**TECHNICAL MEMORANDUM**

**Re:** **RI Phase 2 Modification No. 15**  
**Nevada Environmental Response Trust Site**  
**Henderson, Nevada**  
**Ramboll Project No. 1690006943-011**

Figure  
**1**

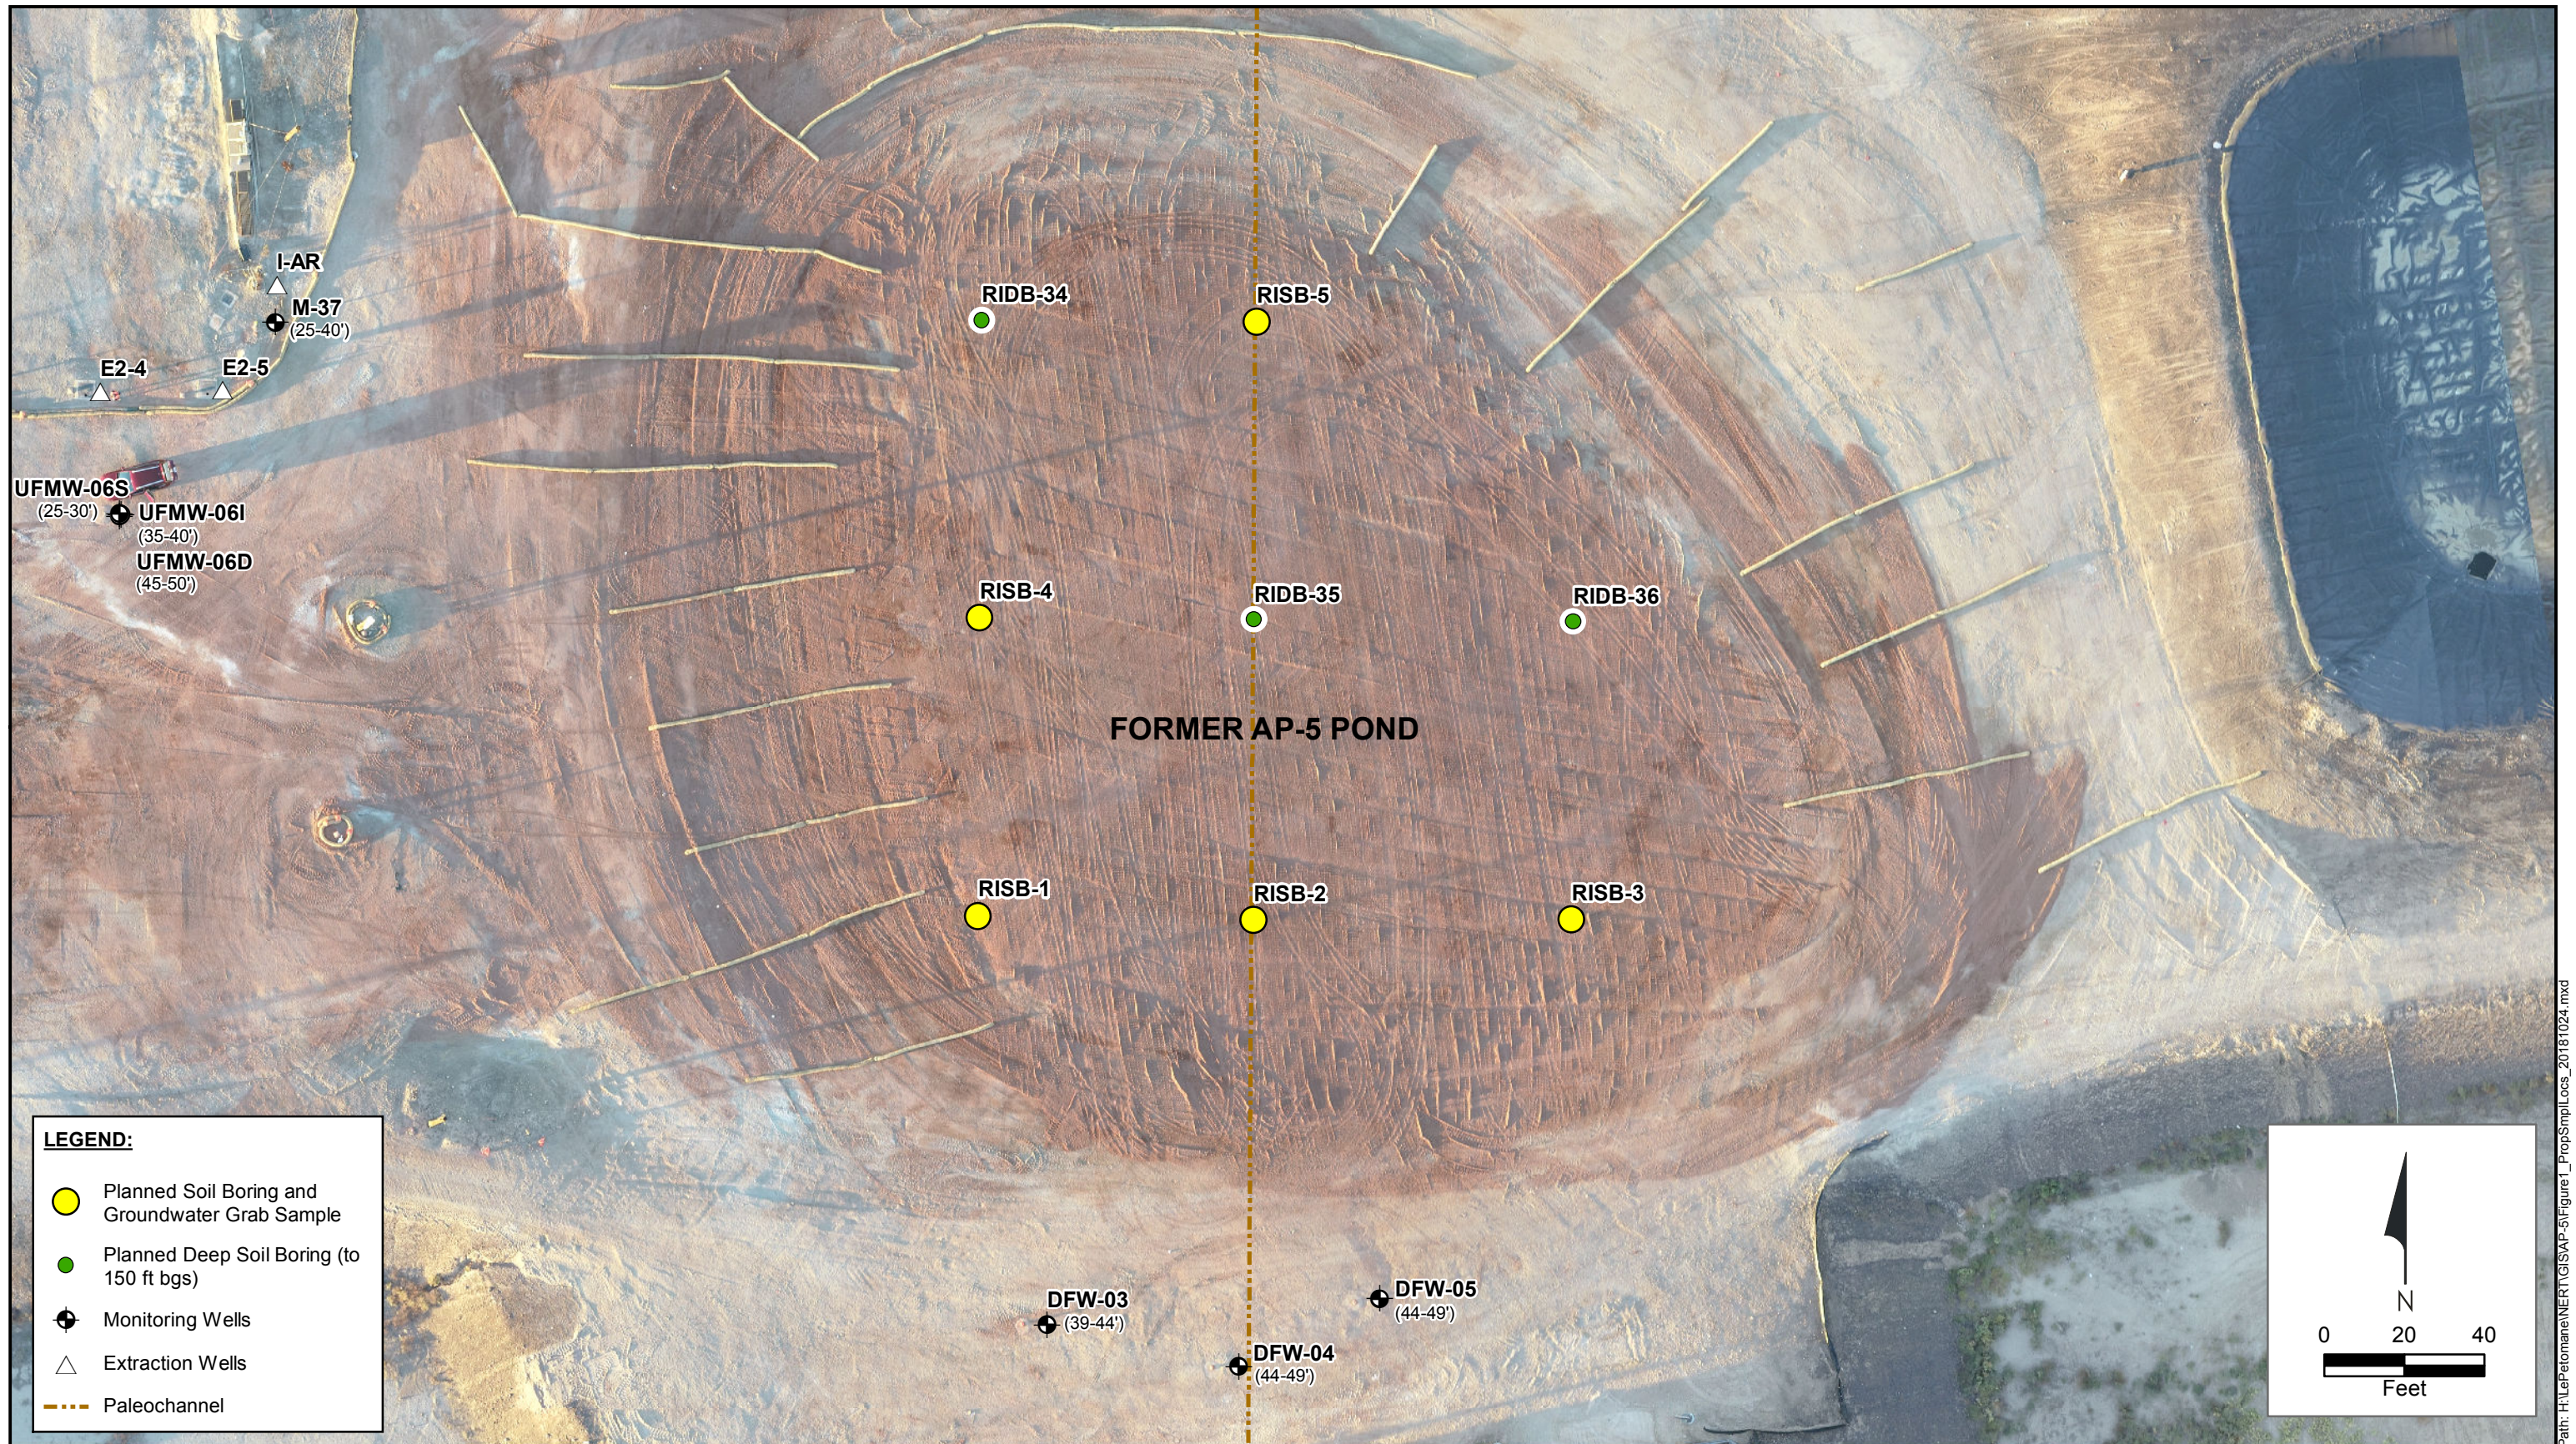
Several new shallow groundwater monitoring wells have been installed in the vicinity of the former AP-5 Pond as part of treatability studies conducted by Tetra Tech. Three of these wells (DFW-03, DFW-04, DFW-05) are located immediately south (upgradient) of the former AP-5 Pond, and well cluster UFMW-06S/-06I/-06D is located to west in the former AP Plant area (see Figure 1). The depth to groundwater in this part of the Site is approximately 30-35 feet below ground surface (bgs), and the deepest of these wells is screened from 45-50 feet bgs. Since additional data are now available for shallow groundwater in this area, the original AP-5 Pond sampling plan will be modified to include deeper investigation locations, as described below. The investigation locations are shown on Figure 1.

- Five borings (RISB-1 through RISB-5) will be advanced and sampled as presented in the 2014 FSP. One-time groundwater samples will be collected at the water table at

- Three deeper borings (RIDB-34, RIDB-35, RIDB-36) will be drilled to a total depth of 150 feet bgs. Soil samples will be collected generally at 10-foot intervals for chemical analysis to provide data to assess the vertical extent of COPCs, particularly in the Upper Muddy Creek Formation (UMCf). The sampling and analysis plan is presented in Table 2 and is based on the sampling plan for RI Phase 2 on-site deep borings.

- Boring RIDB-35 is positioned over the projected location of a paleochannel that extends beneath the former AP-5 Pond. Gravels likely associated with the paleochannel were identified between depths of 30-39 feet bgs at the upgradient well locations DFW-04 and DFW-05. Following completion of boring RIDB-35, up to three clustered monitoring wells will be installed at this location to assess both shallow and deeper groundwater beneath the former AP-5 Pond. Table 3 presents the planned well construction and proposed analytical scheme, which are consistent with the analytical parameters chosen for the Phase 2 RI groundwater investigation within the Site. However, the planned well screens may be adjusted if permeable zones in the UMCf are encountered in soil boring RIDB-35.
